City of Red Bank
Municipal Planning Commission

WORK SESSION AGENDA
October 19, 2021
12:00 pm
Red Bank Community Center

To: Members of the Red Bank Planning Commission
Cc: Greg Tate, Public Works Director
From: Ashley Gates, Regional Planner
Date: October 14, 2021
Subject: Design Review of Fast Pace Clinic at 4104 Dayton Boulevard

Proposed Site, 4104 Dayton Boulevard

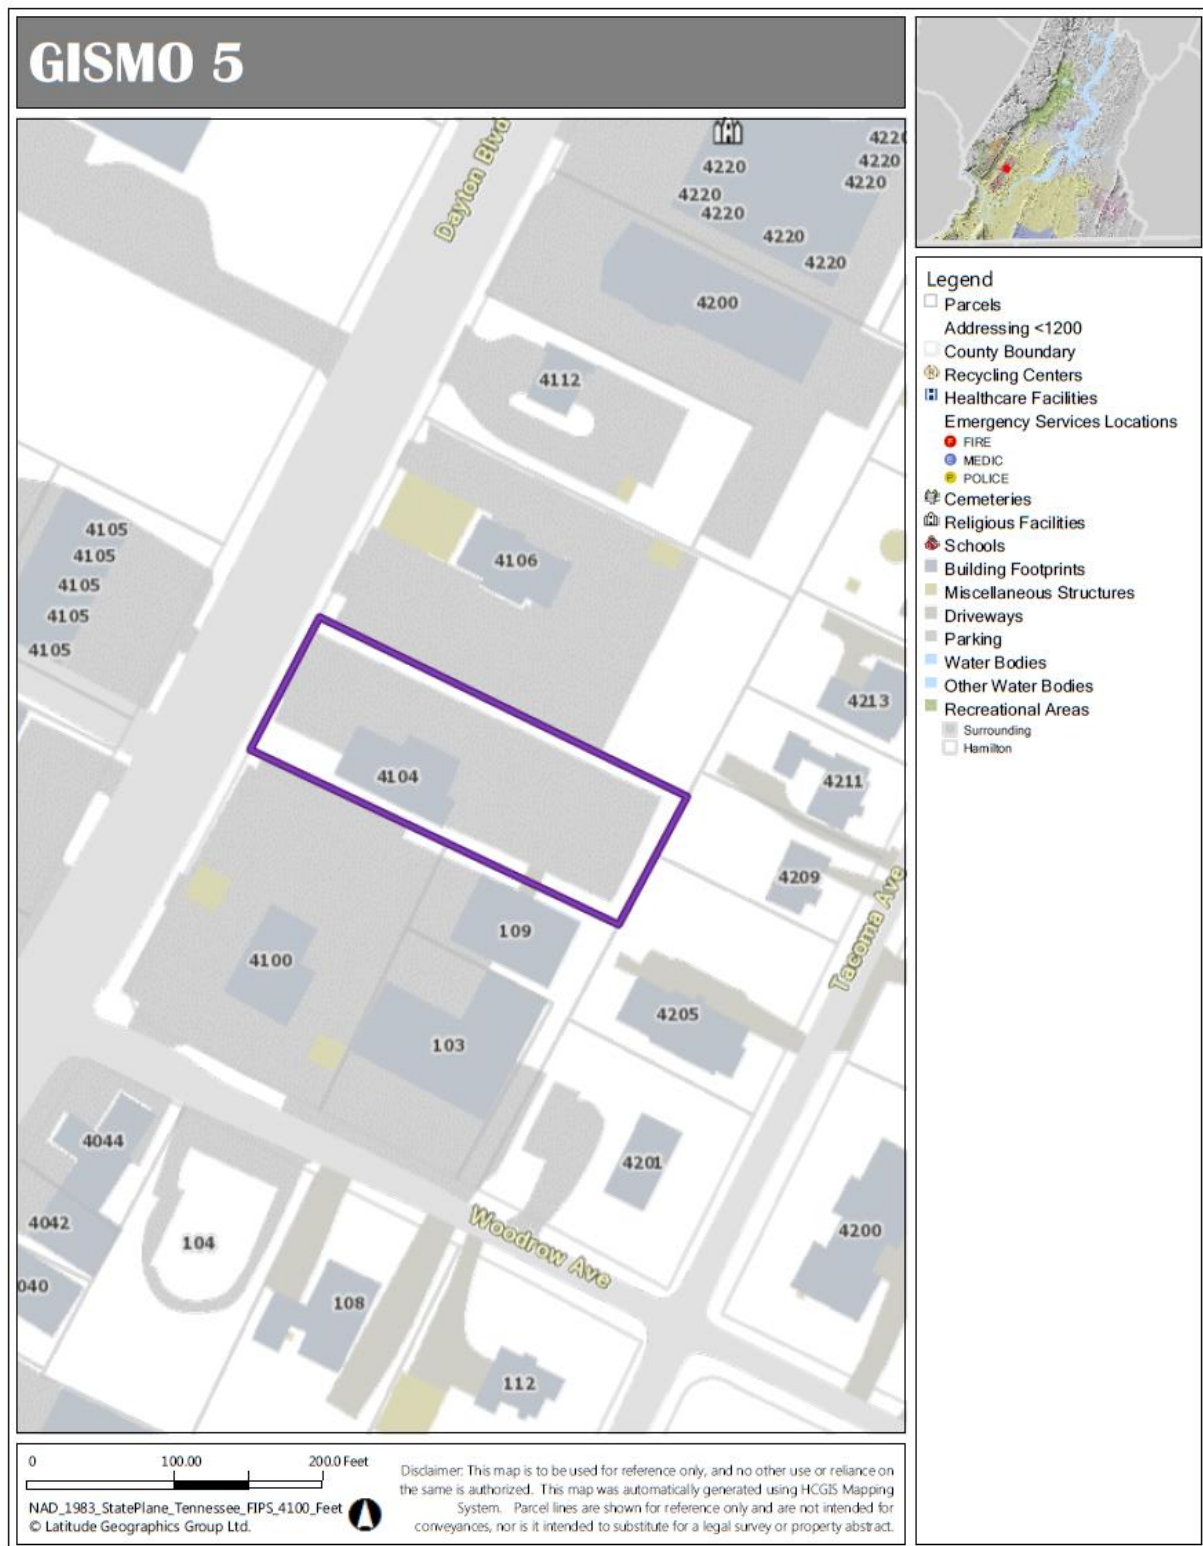
Section 402.03 (I) requires that medical clinics be subject to the issuance of a Special Exceptions Permit when the property abuts a residential district. This lot abuts three R-1 zoned lots, two of which have residential structures. The proposed site plan meets the following requirements of the Zoning Ordinance:

- A landscaped buffer meeting the Type B requirements (minimum 20 feet) between the parking lot and the residences
- 20 parking spaces provided, exceeding the minimum of 11 spaces
- Building situated within the setback requirements of C-1

- An urgent care clinic is compatible with the neighboring commercial uses
- The screening at the rear of the property would be sufficient to limit the impact on the neighboring residences
- All traffic impacts would occur on Dayton Boulevard, not the residential street

Staff Recommendation: Approval.

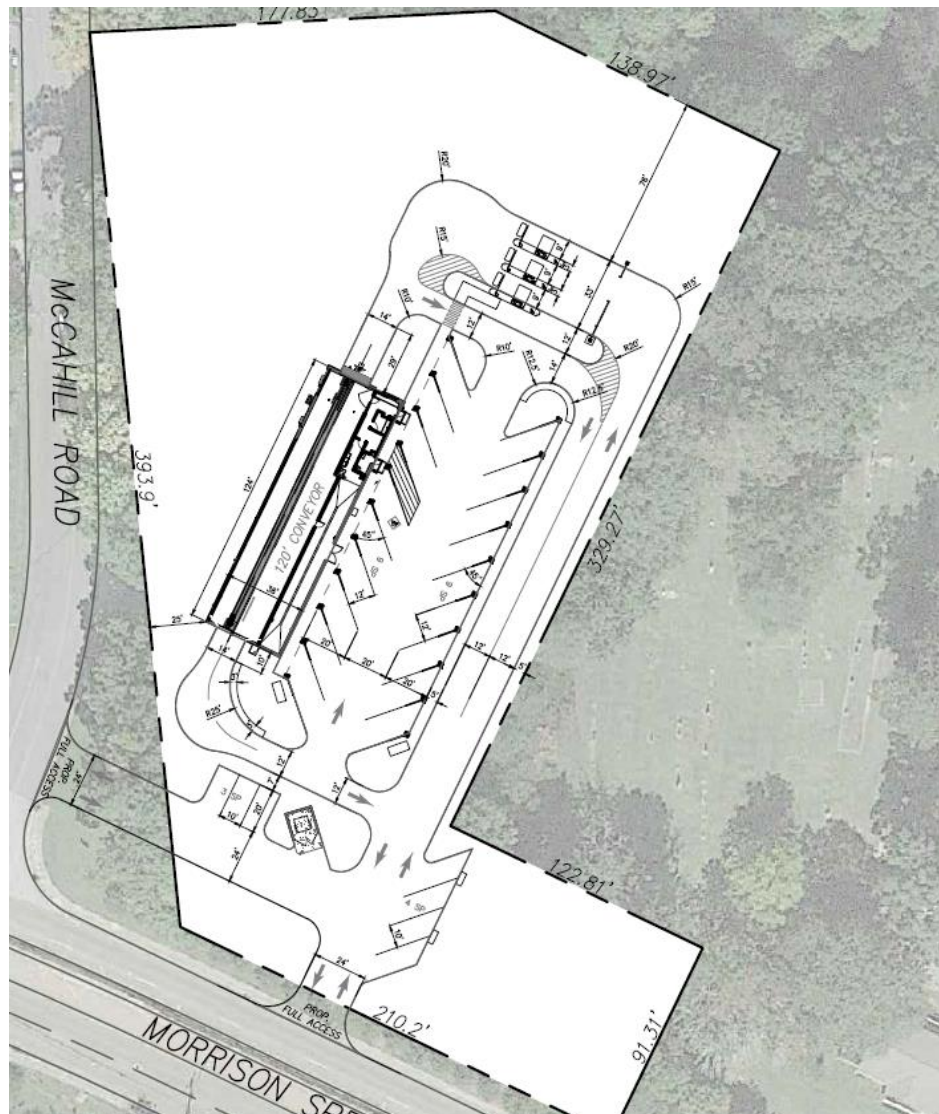
Mudwash RE, LLC has requested that the property be rezoned to C-1 in order to build a car wash business. A preliminary site plan is shown below. The site plan shows a 124' by 36' building to house the car wash, plus 18 parking spaces, presumably with vacuum stations. Seven additional parking spaces are provided.

Internal circulation consists of a one-way, 24-foot-wide loop. It expands to 33-feet wide for three pay stations at the rear of the site. The ingress and egress are 24 feet wide, with one access along Morrison Springs Road and one along McCahill Road.

1. The C-2 zone is intentionally designed with the intent to extend from Dayton Boulevard to Highway 27. Rezoning this to C-1 would allow a wide range of uses, including pawn shops, car dealerships, outdoor storage, and gas stations.
2. The proposed zone is not compatible with the adopted land use plan.
3. The use is potentially incompatible with abutting residential uses due to the noise of vacuuming stations and the potential traffic volume.

If the Planning Commission wishes to rezone this property, staff recommends that the applicant be given 12 months from the lifting of the sewer moratorium to secure a special exceptions permit. Should the permit not be obtained, the zoning should revert to C-2.
